Re: Texas Brine Company Saltville, LLC
Permit # VAS3G931BSMY
November 8, 2007
Proposed Amendment of Permit

Re: Saltville UIC Permit 
Steve Platt to: Jeff McCartney
Cc: James Bennett, Dave Rectenwald

BRINE WELL 1A to Brine Well 131 PIPING SCHEMATIC

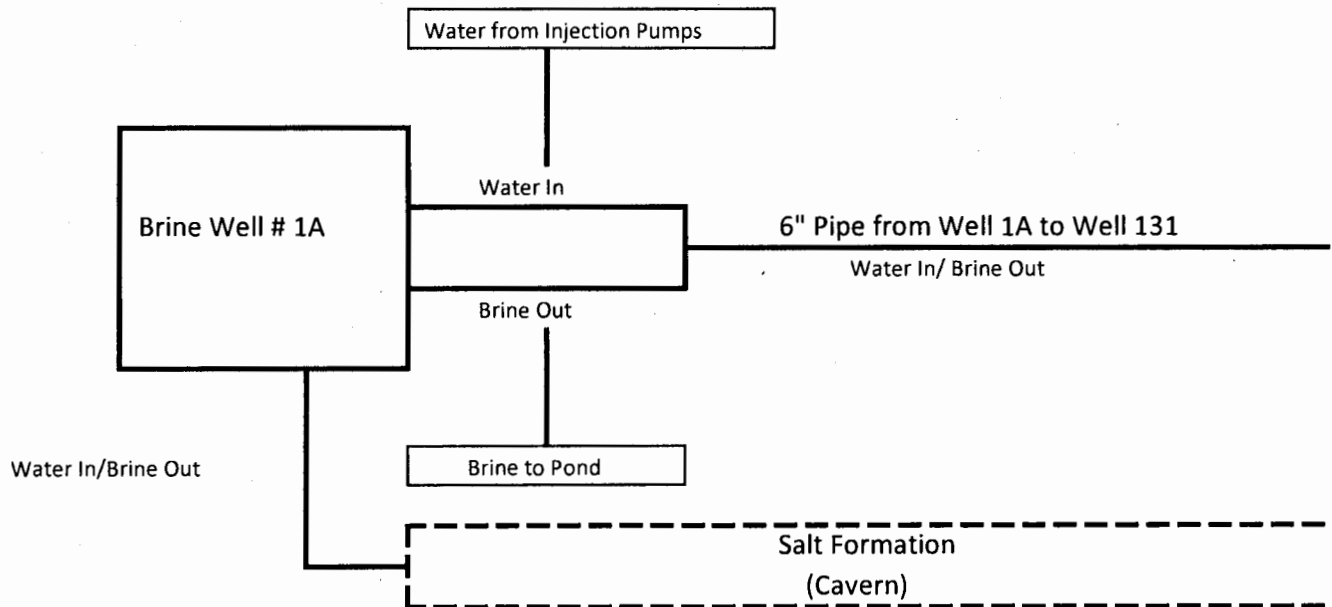
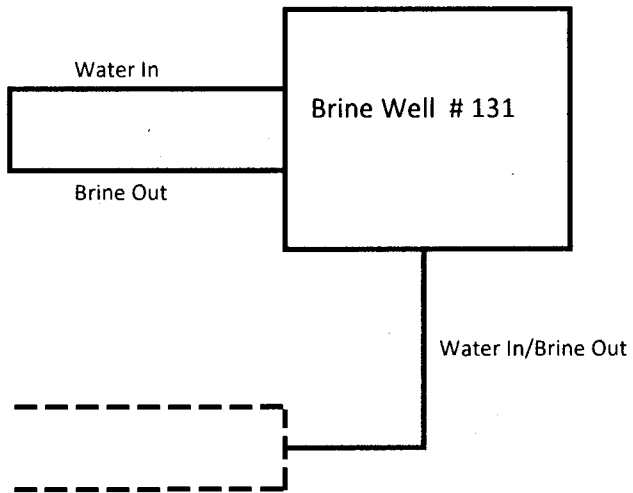
Once we make the horizontal connection between Well 131 and Well 1A, we plan to operate these two wells in a gallery system under the same permit conditions as we are currently operating gallery Wells 13 and 14 and soon to be operating gallery Wells 9 and 17.
